A Townhouse Development at
Walton Cr Rd/ Village Dr
1805 Walton Creek Road, Steamboat Springs, Colorado 80487

DATE	DESCRIPTION
12/20/21	100% DD
05/20/22	50% CD
06/17/22	100% CD/ PERMIT
09/07/22	PERMIT CORRECTIONS

REVIEWED FOR CODE COMPLIANCE
12/07/2022

A0.00

A0.02

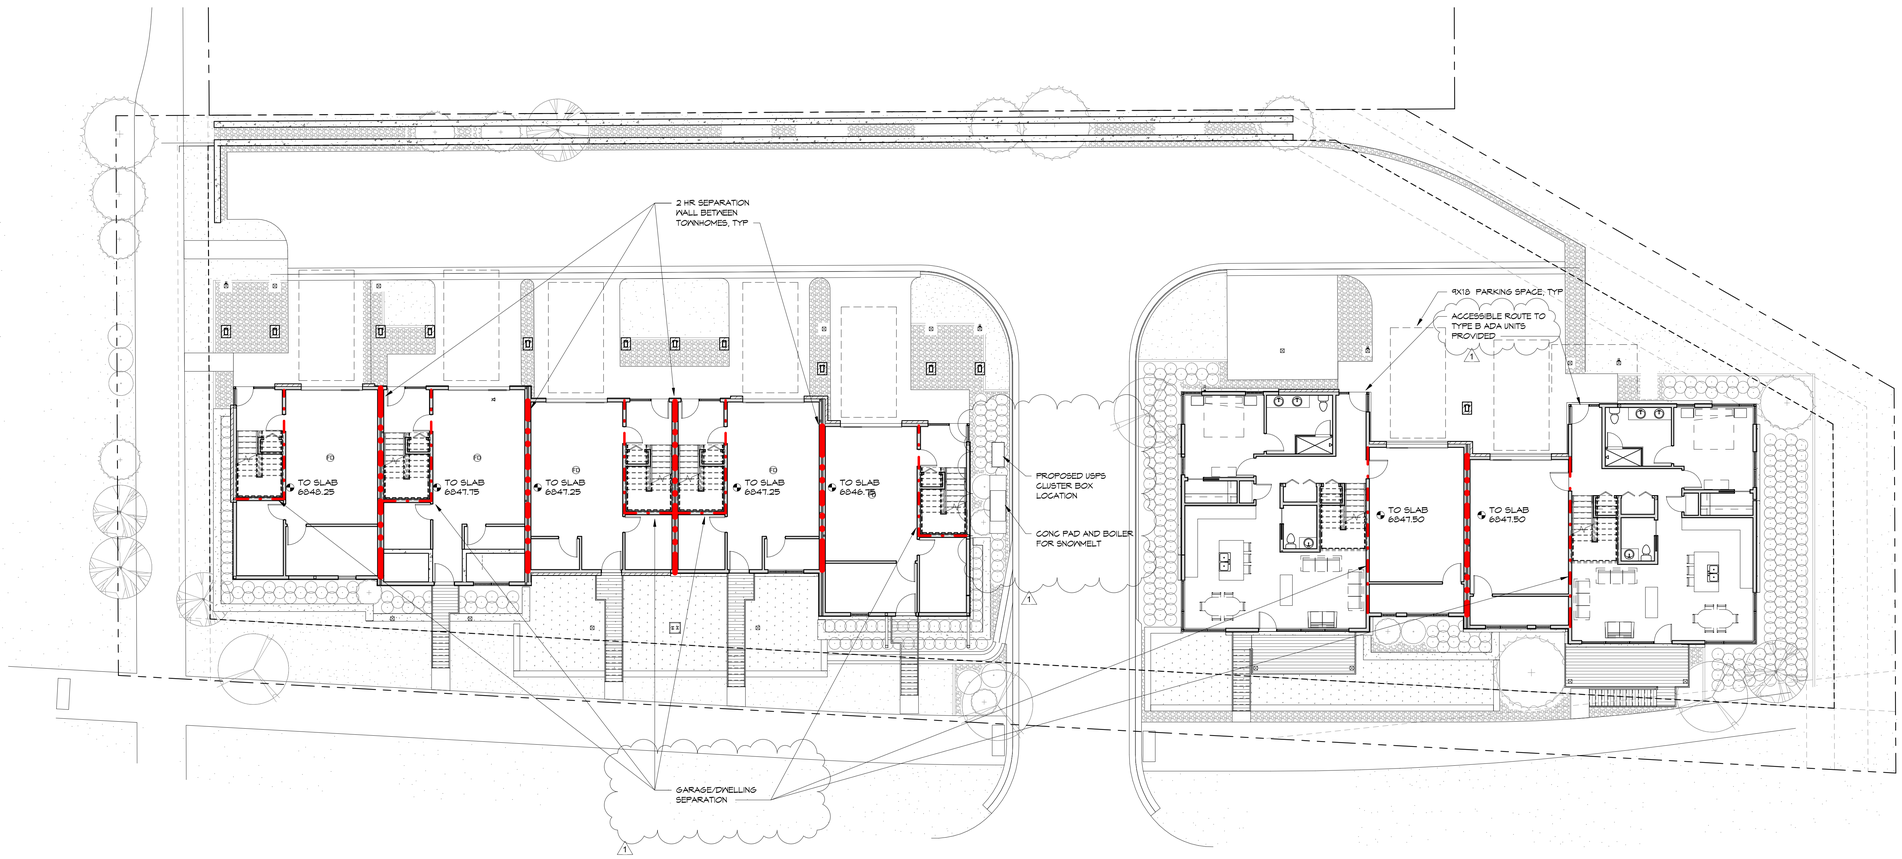
RCRBD Comment: Please call to discuss this penetration, 'm trying to find this detail on the structural walls with the compression plate, but cannot locate it. It may meet the exception under section. We will need to know the exact p
R302.2.6Structural Independence:
Each individual townhouse shall be structurally indepen
Exceptions:

1. Townhouses separated by a common wall as provide
R302.2.2Common walls.
Common walls separating townhouses shall be assign
Penetrations of the membrane of common walls for ele

2. Where a fire sprinkler system in accordance with Se
s this penetration, 'm trying to find this detail on the structural walls with the compression plate, but cannot locate it. It may meet the exception under section. We will need to know the exact p
hall be assigned a fire-resistance rating in accordance with Item 1 or 2. The common wall shared by two townhouses shall be constructed without plumbing or mechanical equipment, ducts or vents
n walls for electrical outlet boxes shall be in accordance with Section R302.4.
dance with Section P2904 is not provided, the common wall shall be not less than a 2-hour fire-resistance-rated wall assembly tested in accordance with ASTM E119, UL 263 or Section 703.3 of the
vall as provided in Section R302.2.2; Item 1 or 2.
turally independent.

NORTH BUILDING - FIRST LEVEL FLOOR PLAN

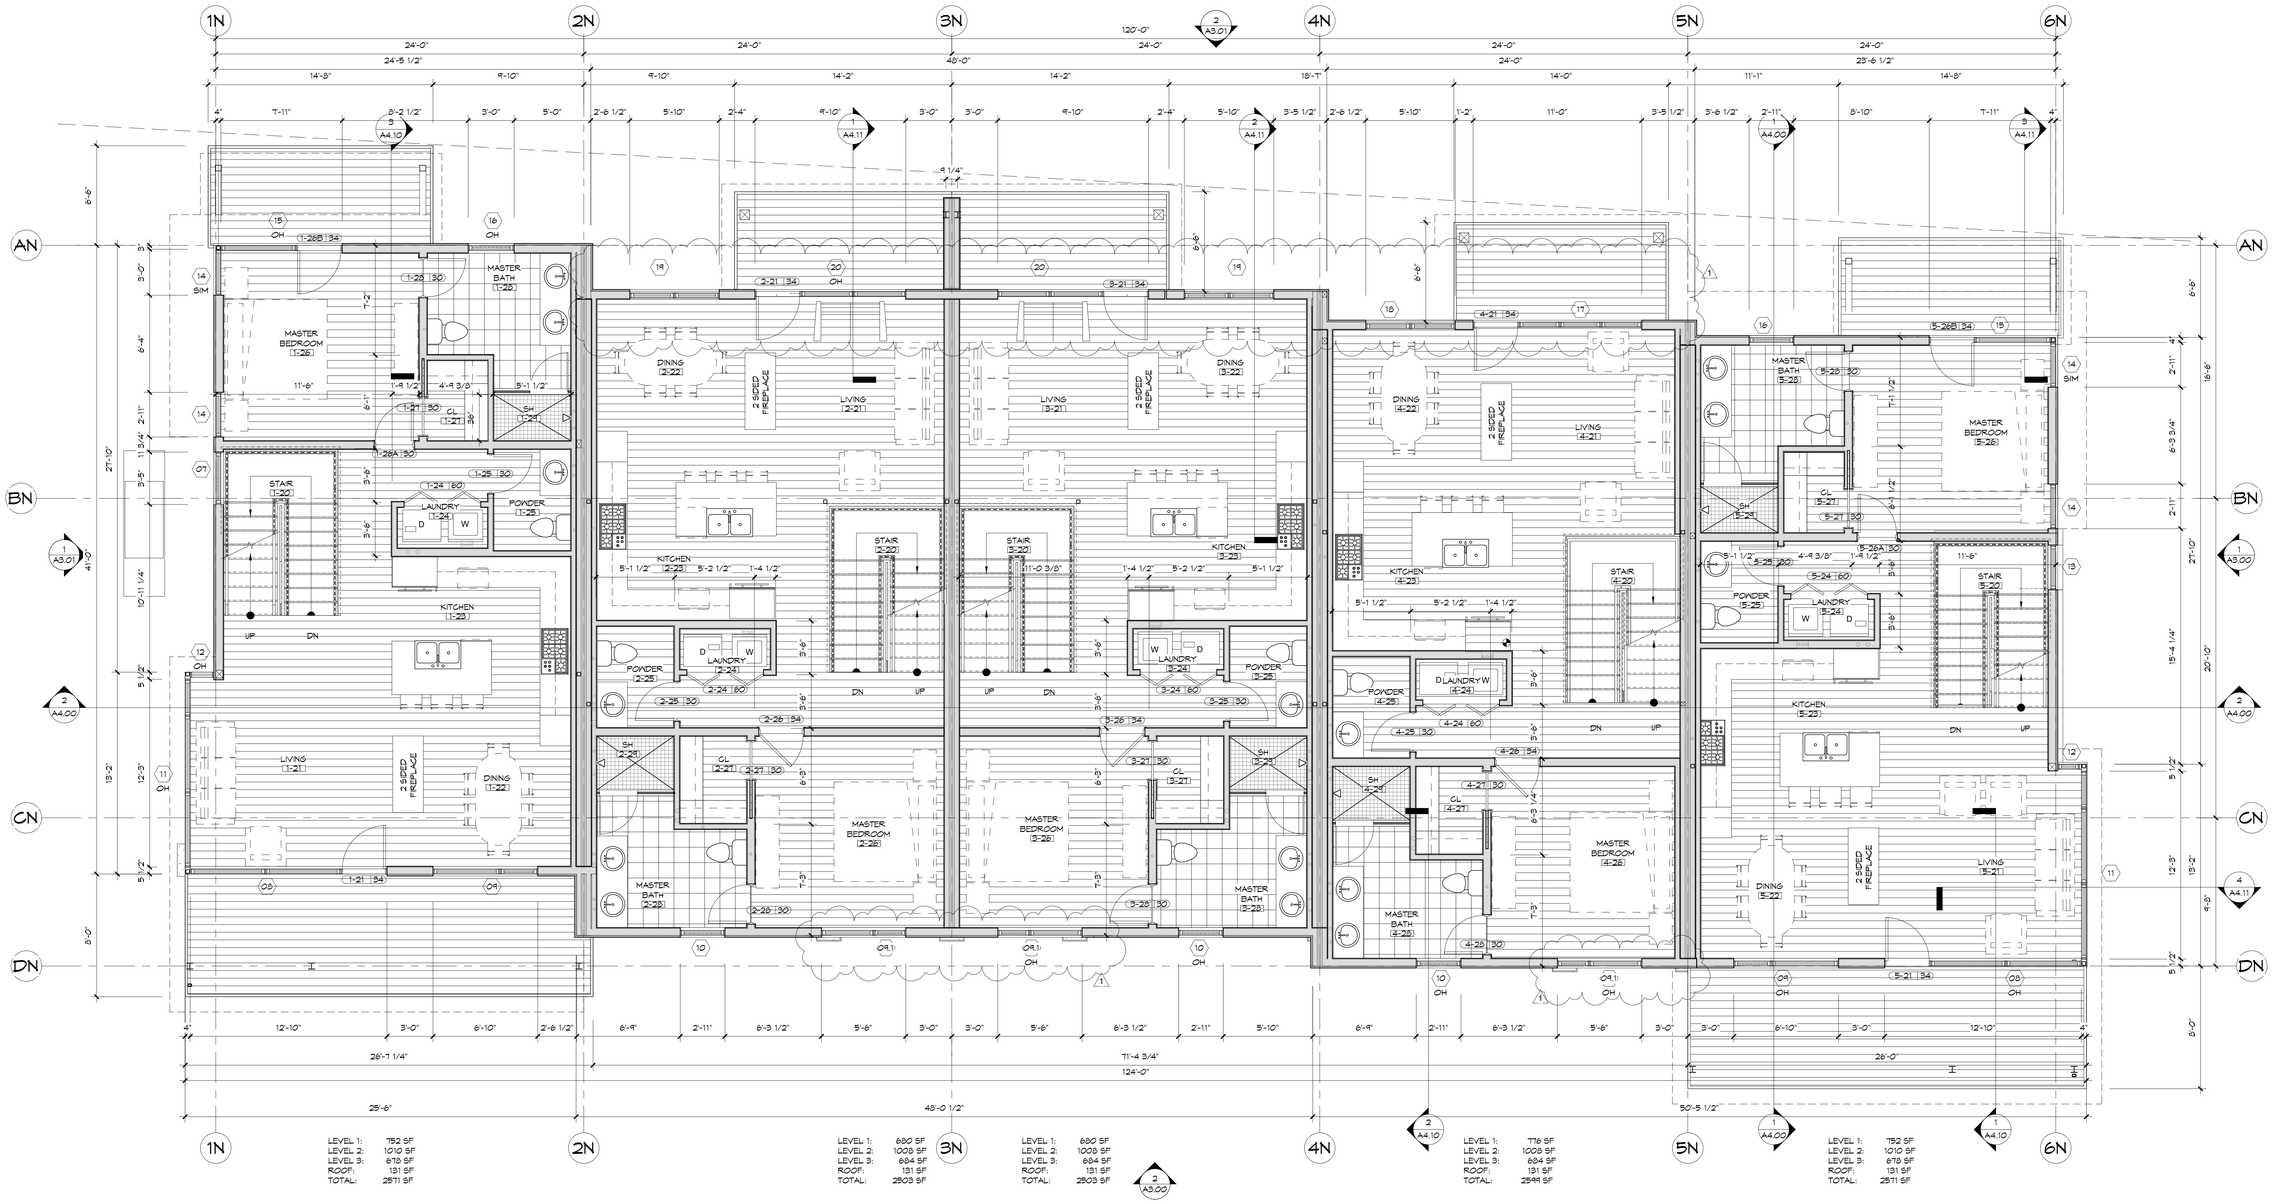
please add notes as to what is considered dwelling space versus garage space, then provide us with garage/dwelling separation for walls and required doors as well. We are unsure if the storage room is part of the garage or dwelling, same is true for mechanical room. If mechanical room is considered garage, please review all penetrations and/or ductwork sections applicable to this. Response needed per unit and per building.

NORTH BUILDING - THIRD LEVEL FLOOR PLAN

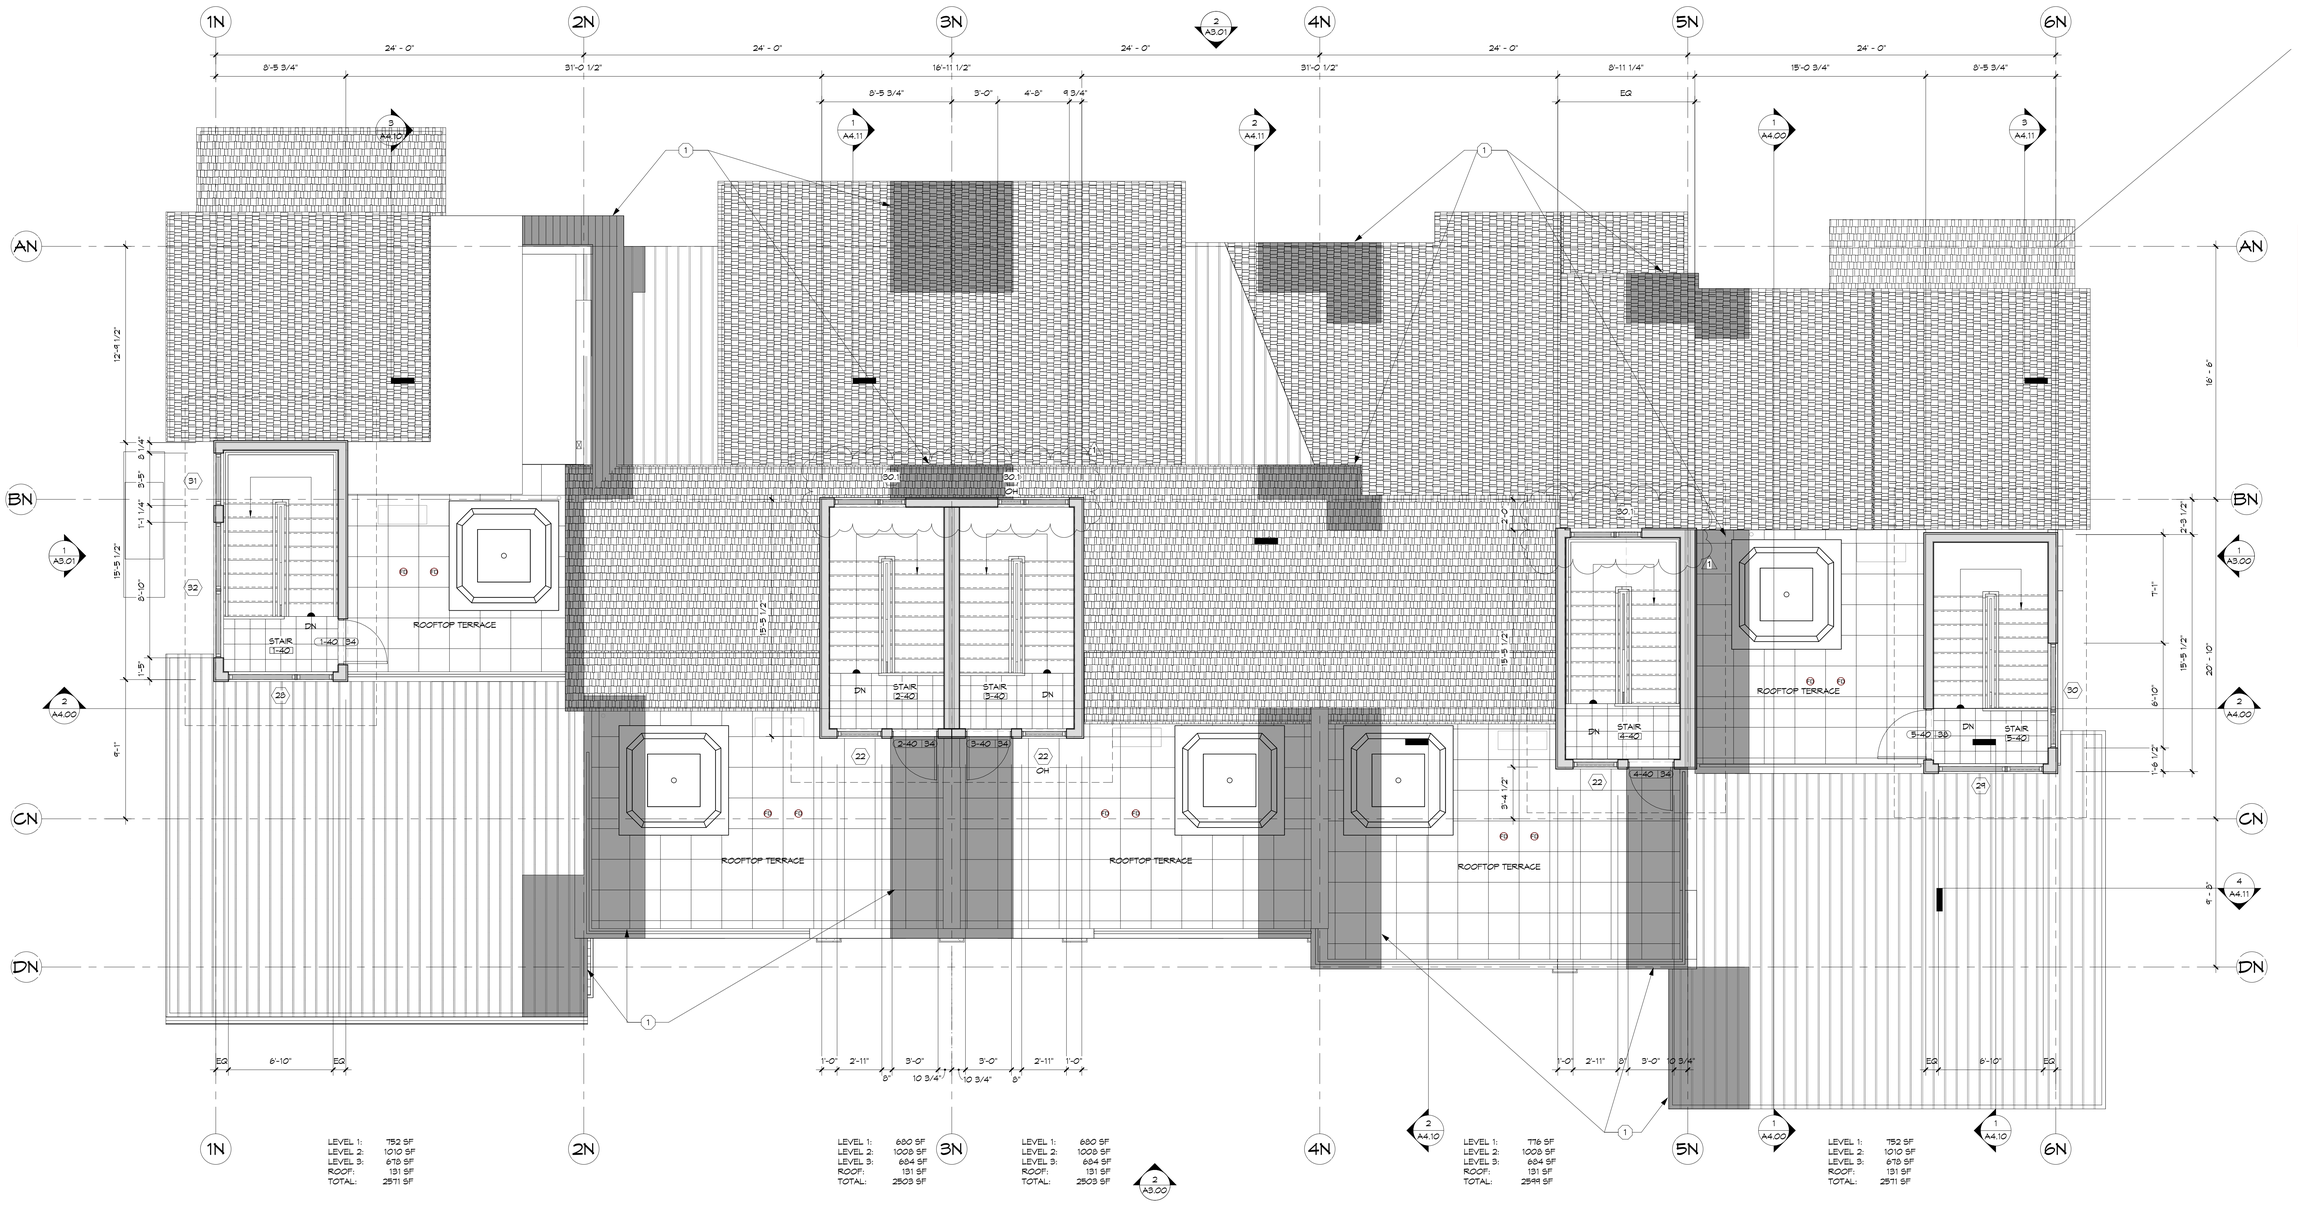
Windows are not allowed within 3 feet of a property line per R302.1(1) table, we can accept a code modification request if they were 1-hour rated non operable windows in combination with a No-Build Easement agreement that would need to be discussed on the wording and recording to allow the openings.

Same comment on openings along a property line.

1. ONE HOUR PROTECTION OF SOFFIT ON THE UNDERSIDE (SEE DETAIL 2/A0.02 AND FRTN ON BOTH SIDES OF THE ROOF WITHIN 4' OF THE PROPERTY LINE BETWEEN THE TOWNHOMES

SOUTH BUILDING - FIRST LEVEL FLOOR PLAN

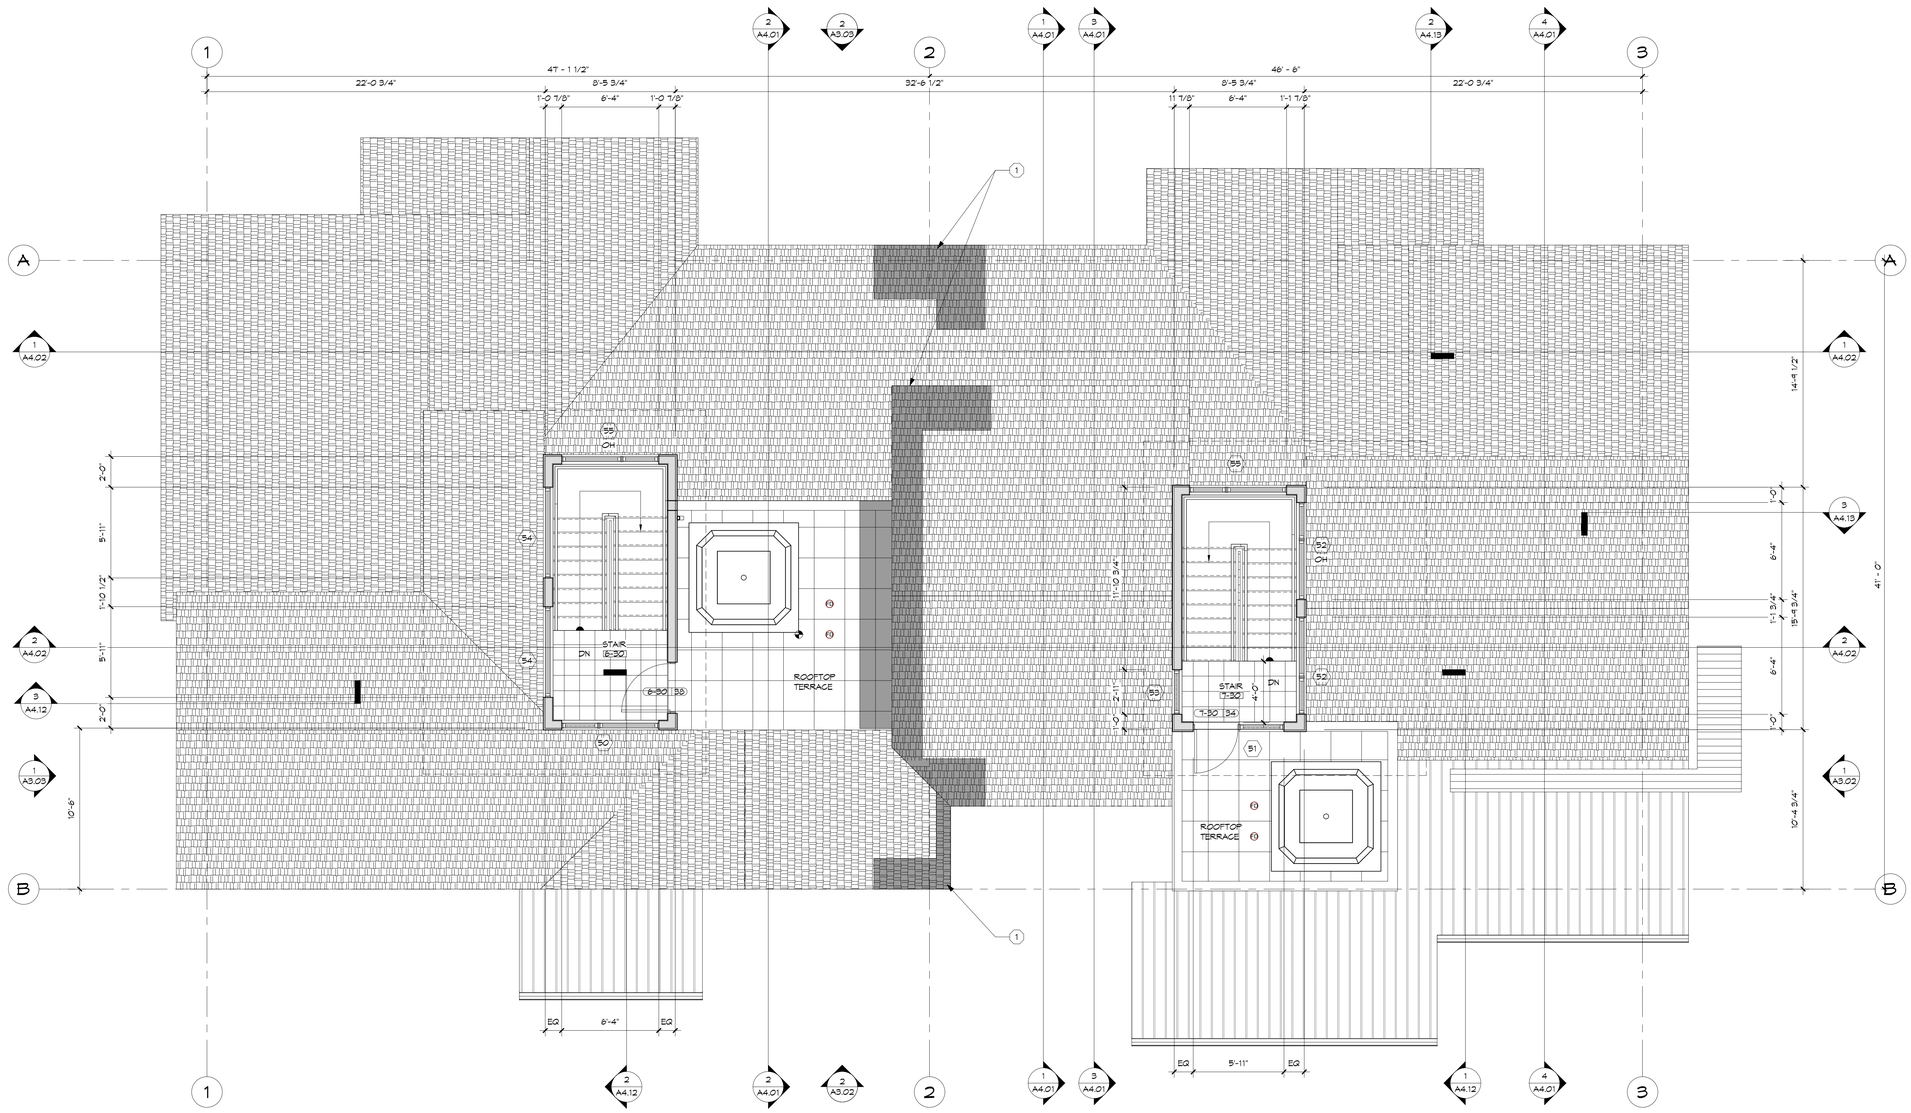
Same comment, need to know where garage/dwelling separation is going to be.

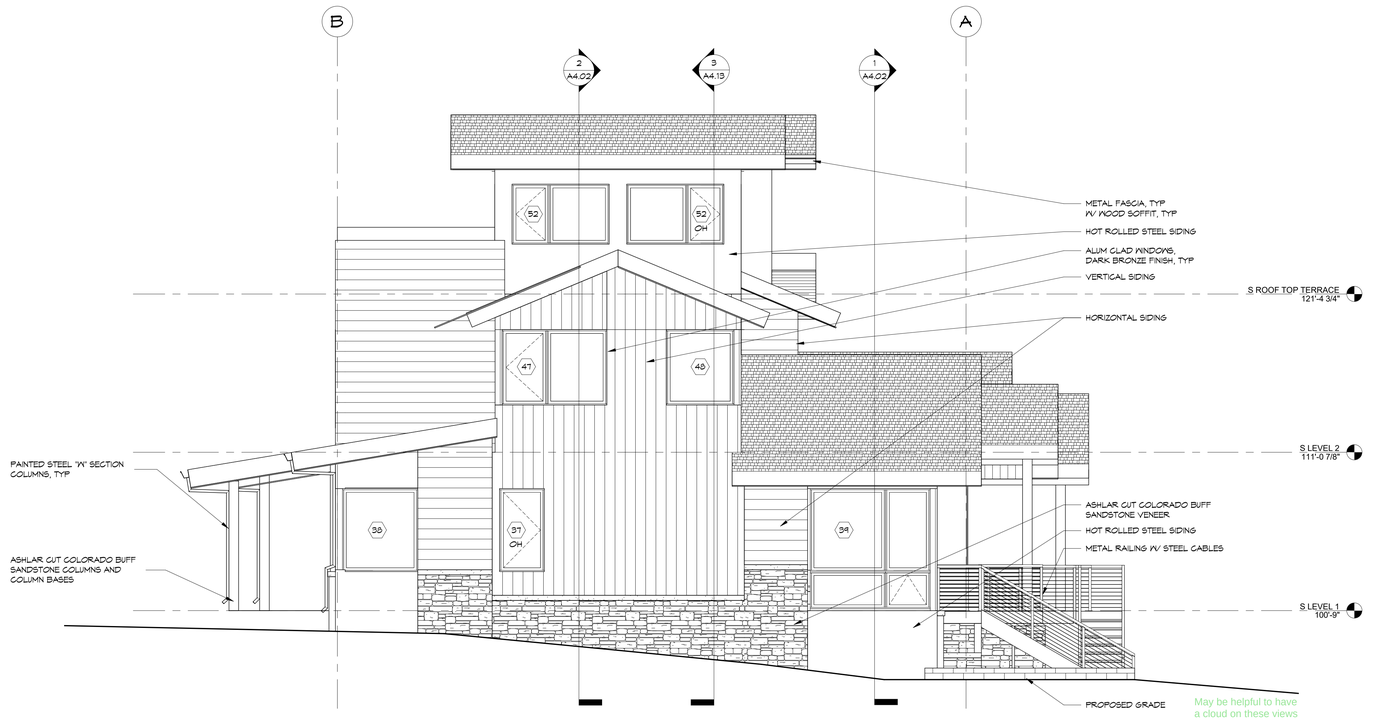
How will the shaft wall continue through the trusses on this roof plane, I assume the truss has a flat bottom chord and not sure how the 2-hour wall will be built through the trusses.
